This letter is a request to an amendment to AP.CO's Source Material License #SUA-1470, for the following items:

Design Modification Amendment Request

ARCO Bluewater Mill
Reclamation Plan

LICENSE NO. SUA-1470
DOCKET NO. 40-8902

FIGURE 3.1
MAIN TAILINGS IMPOUNDMENT
DESIGN MODIFICATION

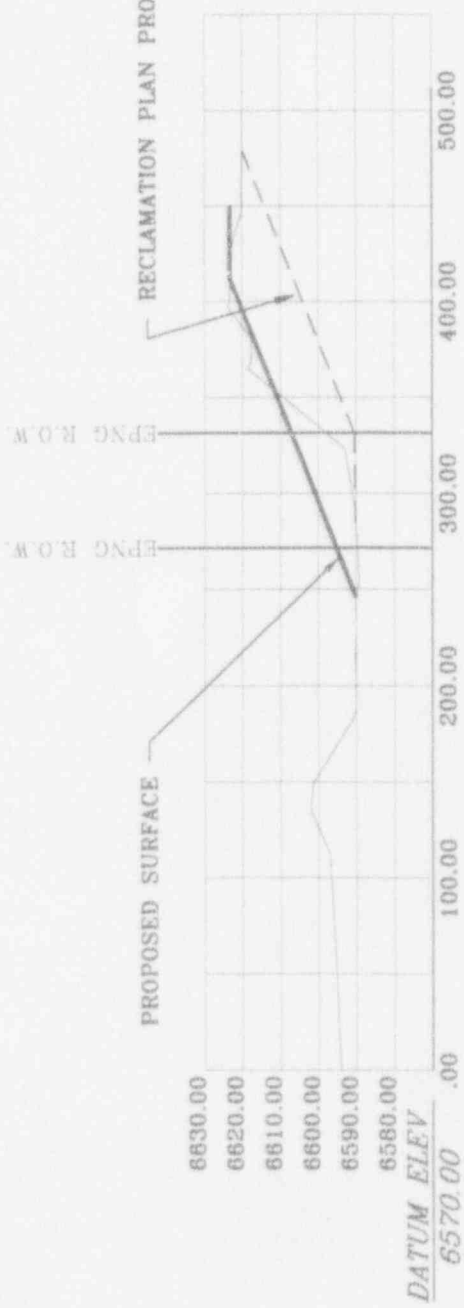
ARCO proposes to modify the Main Tailings Impoundment slope design contained in the 1990 Reclamation Plan between stations 75+00 and 86+00. (Figure 3.1) The 30 inch El Paso Natural Gas pipeline is to be relocated away from the present toe of the Main Tailings Impoundment at this location. The slope along the El Paso Natural Gas pipeline will be a cut and fill operation and extend over the former location of the El Paso right-of-way.

The slope will be modified from the 1990 Reclamation Plan to reduce the quantity of material excavated due to removal of the gas pipeline as shown on Figure 3.2. With no constraint on the slope toe from the El Paso right-of-way less cut is required to construct the reduced slope. The reclaimed slope geometry will remain 5 horizontal to 1 vertical. The slope geotechnical stability will be enhanced because of less cut into the tailings impoundment and will be similar to that of the Main Tailings slopes with cut/fill type construction. Slope geotechnical analysis of this area completed for the 1990 Reclamation Plan indicates the slope is stable under static and pseudo- static conditions.

FIGURE 3-2
 MAIN TAILINGS IMPOUNDMENT
 TYPICAL SECTION

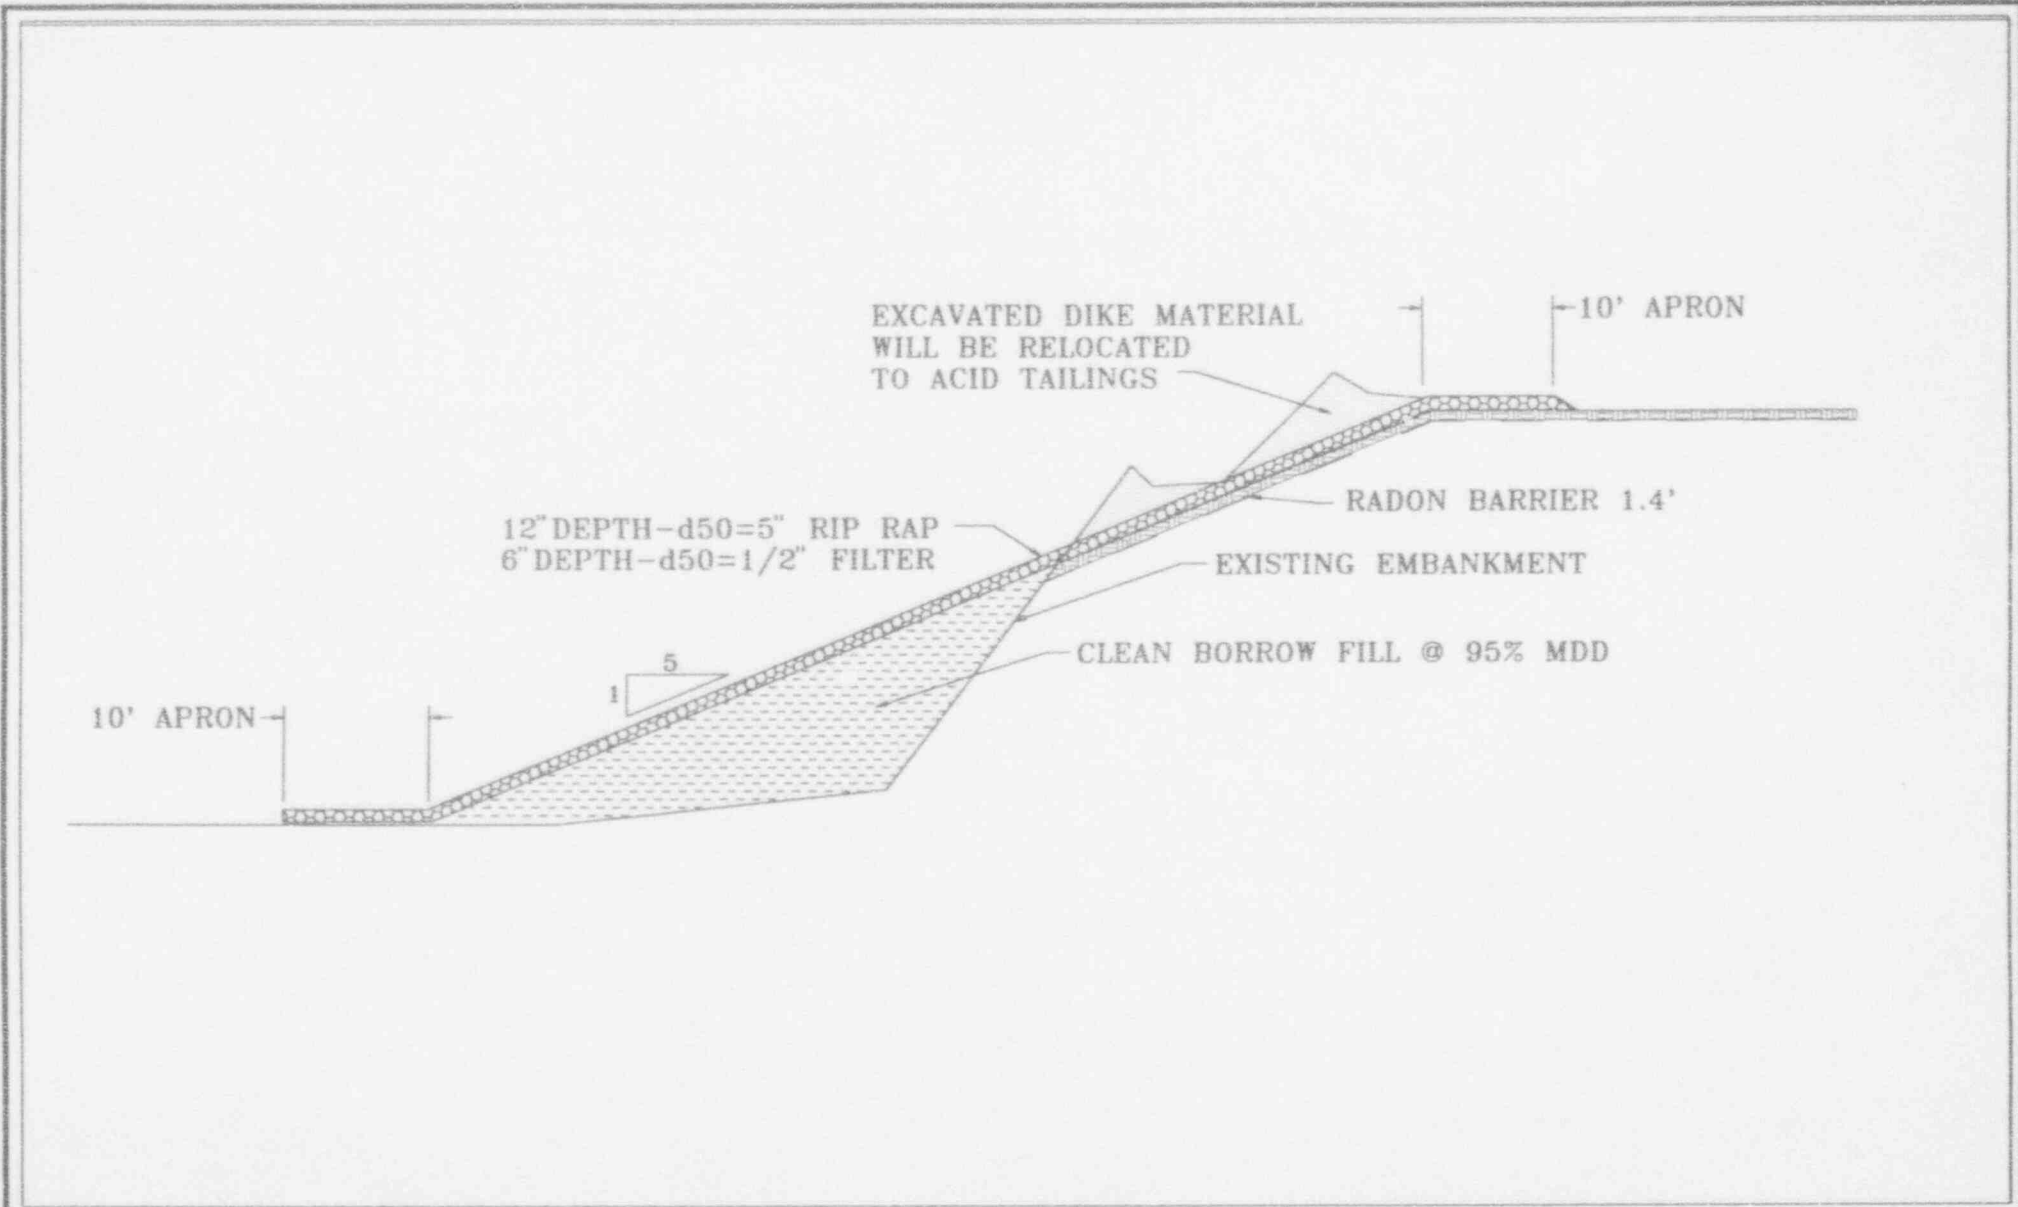
Removal of material at the upper portion of the slope will consist of sand tailings and embankment soil. This material will be excavated and placed onto the Acid Tailings Impoundment and compacted to 95% of Maximum Dry Density (MDD) in compliance with Reclamation Plan specifications. The fill material at the slope toe will be soils obtained from the borrow site or the evaporation pond dikes, and compacted to 95% MDD. Radon barrier is to be constructed over the tailings exposed by excavation. The depth of radon barrier is to be 1.4 feet which meets specifications for the sand tailings proposed in ARCO's Final Radon Barrier Design

Report - December 1993. Figure 3.2 shows detail of the slope construction.
